SUBJECT: Harvest/Survey Program 22H04 – Supplement #1 Certain 2022 Model Year Super Duty Lower Steering I-Shaft Bolt

New! <u>REASON FOR THIS SUPPLEMENT</u>

Attachments: Technical instructions have been updated with clearer photos of a does not pass bolt. *Labor Allowances:* Labor allowances have been updated to reflect the technical instructions.

FIGURE 2

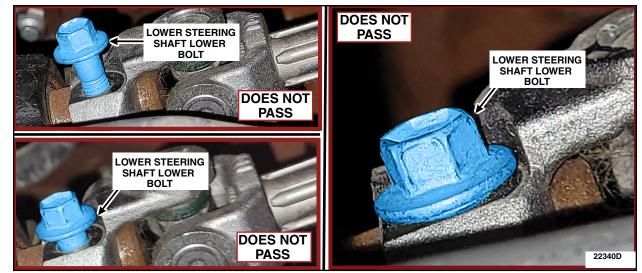
CPR © 2022 FORD MOTOR COMPANY DEARBORN, MICHIGAN 48121 09/2022 NEW ! 2. Is there a gap between the lower steering shaft lower bolt and the steering yoke? See Figure 2.

- NO Passes inspection. Inspection procedure is complete. Proceed to Step 3.
- YES Does not pass inspection. Capture and submit clear photo(s) to the Special Service Support Center (SSSC) showing the gap between the lower steering shaft lower bolt and the steering yoke. Replace the lower steering shaft lower bolt. Please follow the Workshop Manual (WSM) procedures in Section 211-04. If the I-Shaft is damaged, please contact the SSSC for further direction.
